UNITED STATES
DEPARTMENT OF THE INTERIOR
BUREAU OF LAND MANAGEMENTFORM APPROVED
OMB NO. 1004-0135
Expires: July 31, 2010**SUNDRY NOTICES AND REPORTS ON WELLS**
*Do not use this form for proposals to drill or to re-enter an abandoned well. Use form 3160-3 (APD) for such proposals.***SUBMIT IN TRIPLICATE - Other instructions on reverse side.**

1. Type of Well <input checked="" type="checkbox"/> Oil Well <input type="checkbox"/> Gas Well <input type="checkbox"/> Other		8. Well Name and No. POLO AOP FEDERAL 1
2. Name of Operator YATES PETROLEUM CORPORATION		9. API Well No. 30-015-28170
3a. Address 105 SOUTH FOURTH STREET ARTESIA, NM 88210	3b. Phone No. (include area code) Ph: 575-748-4168 Fx: 575-748-4585	10. Field and Pool, or Exploratory PENASCO; WOLFCAMP
4. Location of Well (Footage, Sec., T., R., M., or Survey Description) Sec 10 T19S R25E NESW 1980FSL 1980FWL		11. County or Parish, and State EDDY COUNTY, NM

**Polo AOP Federal 1
30-015-28170
Yates Petroleum Corporation
August 20, 2013
Conditions of Approval**

Wellbore schematics attached

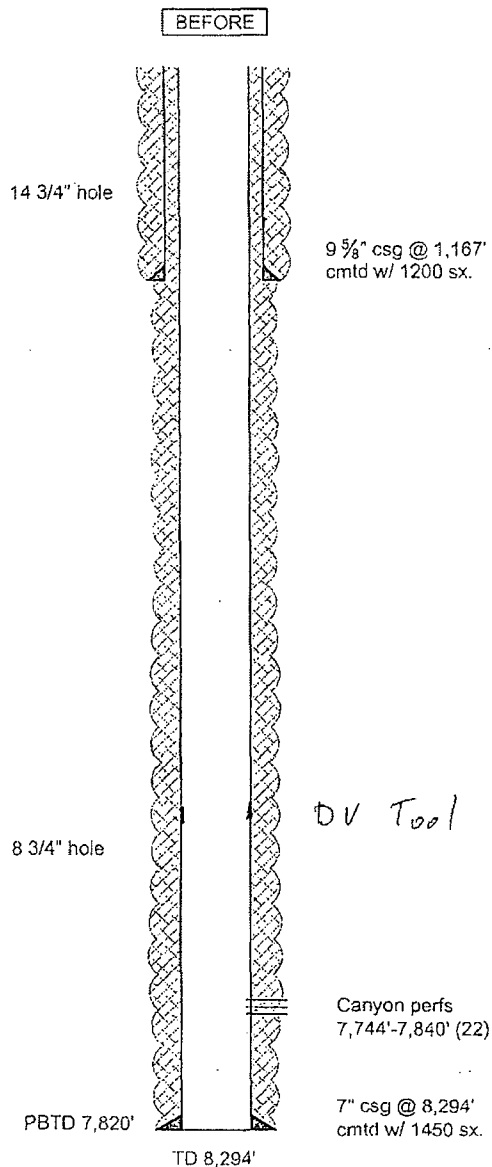
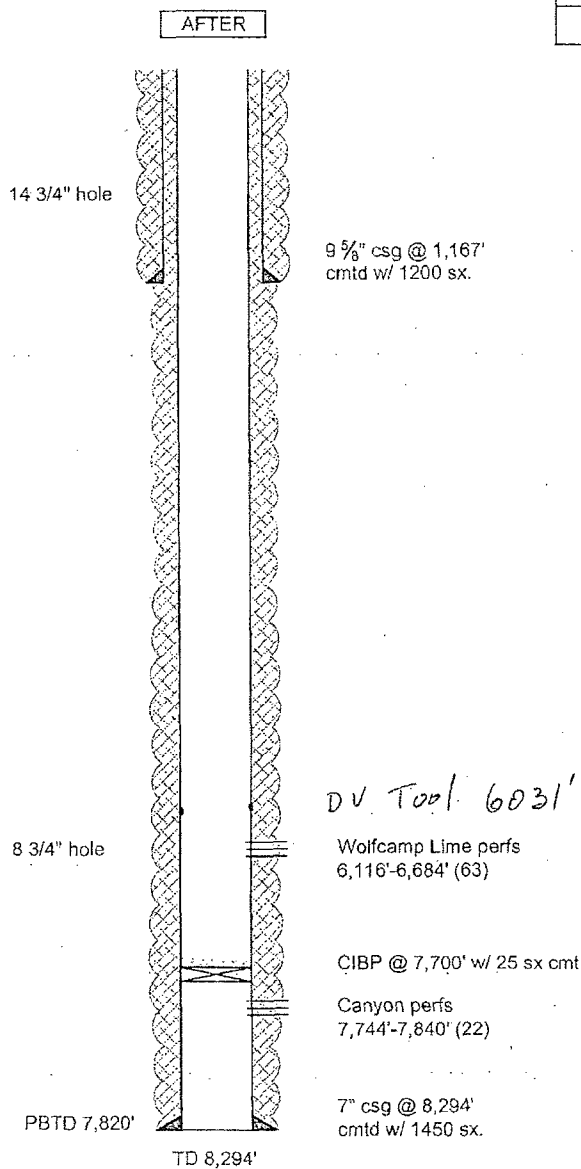
- 1. Operator shall set a CIBP at 7,690' and place 25 sx Class H cement. Tag required.**
- 2. Must conduct a casing integrity test before perforating and fracturing. Submit results to BLM. The CIT is to be performed on the production casing to max treating pressure. Notify BLM if test fails.**

- 3. If CIT passes, recompletion is approved as written.**
- 4. If zone is not productive set CIBP 50'-100' above upper most perms with 25 sx cement on top.**
